Office of the Consumer Advocate

Re: Newfoundland and Labrador Hydro - 2023 Capital Budget Application

CONSUMER ADVOCATE REQUESTS FOR INFORMATION CA-NLH-001 to CA-NLH-094

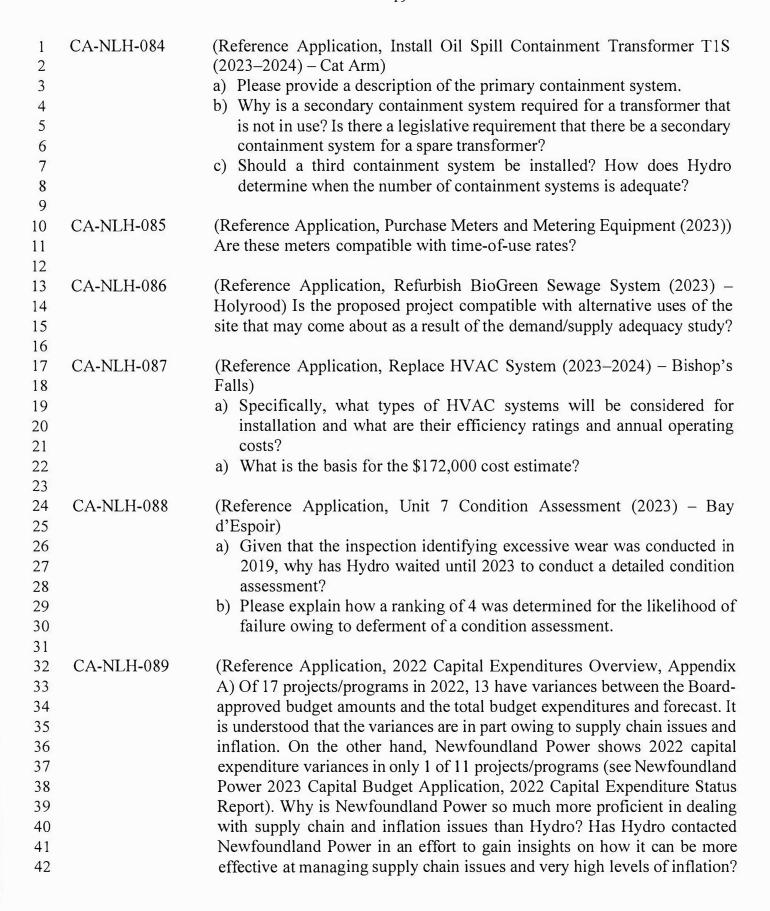
CA-NLH-053 (Reference Application, 2023 Capital Budget Overview, page 30) It is 1 stated with respect to light-duty vehicles "The review is ongoing." When 2 does Hydro expect to complete this review? 3 4 5 (Reference Application, 2023 Capital Budget Overview, Table 6) Have CA-NLH-054 6 these plans been discussed with the relevant industrial customers? 7 8 CA-NLH-055 (Reference Application, 2023 Capital Budget Overview, Chart 20) Does the chart show all-in average rates for all end-use customers? Please show the 9 chart with rates for only residential customers on the Island system, both 10 all-in and energy charge only. What are the all-in and energy rates for 11 residential customers on the Island system in 2022? 12 13 14 (Reference Application, 2023 Capital Budget Overview, Tables 8 and 9) CA-NLH-056 15 a) If the Board were to impose a capital budget envelope, would Hydro use these tables to prioritize which projects would be completed and which 16 projects would not be completed? 17 b) Is Hydro's project prioritization methodology similar to that used by NP 18 in its 2023 Capital Budget Application? What are the primary 19 differences? 20 c) It is noted that the Replace Peripheral Infrastructure (i.e., printers and 21 display units) project has a risk mitigated per \$1 million score of 32.0 22 while the Salmon River Spillway project has a score of only 5.3. Does 23 24 Hydro believe that its prioritization methodology provides an accurate portrayal of relative risk? 25 26 27 CA-NLH-057 (Reference Application, 2023 Capital Budget Overview, Appendix A, page A-9) For "Allowance for Unforeseen Items," for the years 2000 to 2022 28 please provide the amount approved and the amount actually spent. 29 30 (Reference Application, 2023 Capital Budget Overview, Appendix F and 31 CA-NLH-058 pages 34-37) 32 33 a) What was the rationale or precedent for the assignment of index values 34 for likelihoods in the NLH Capital Risk Rating Matrix as 1, 2, 3, 4 and 5? The index value of 1 corresponds to a probably of less than 1 per 35 cent while the index value of 5 corresponds to a probably of greater than 36 90 per cent, which is more than 90 times higher, so isn't using 5 37 underweighting the probably of a likely event in relative terms? Has 38 Hydro considered using the mid-point of each of the 5 categories to 39 reflect the probabilities associated with them, e.g., index number 4 40 corresponds to 50 to 90 per cent so why not use the midpoint of 70 per 41 cent, thereby preserving the mathematical relationship among the 42 probabilities? 43

1 2 3 4 5 6 7 8 9 10 11 12		 b) What was the rationale or precedent for the assignment of index values for impacts in the NLH Capital Risk Rating Matrix as 1, 2, 3, 4 and 5? While there is not an exact mathematical relationship among the impacts, isn't an assigned index value of 3 for a "moderate" impact (where more than 1000 customers are affected) too low relative to a "very-low" impact event (where fewer than 100 customers are affected)? c) Tables 8 and 9, pages 34-37, give very different priority rankings depending on whether the criterion is risk mitigation per \$1 million (Table 7) or risk mitigated (Table 8), e.g., Overhaul of Unit 2 Turbine and Valves (2023) – Holyrood ranks 59 out of 62 projects/programs when the evaluated by risk mitigation per \$1 million while it ranks first
13 14 15		among the 62 according to risk mitigated. Is it possible that these very different rankings are due to a lack of proportionality in the index values used in the Rating Matrix?
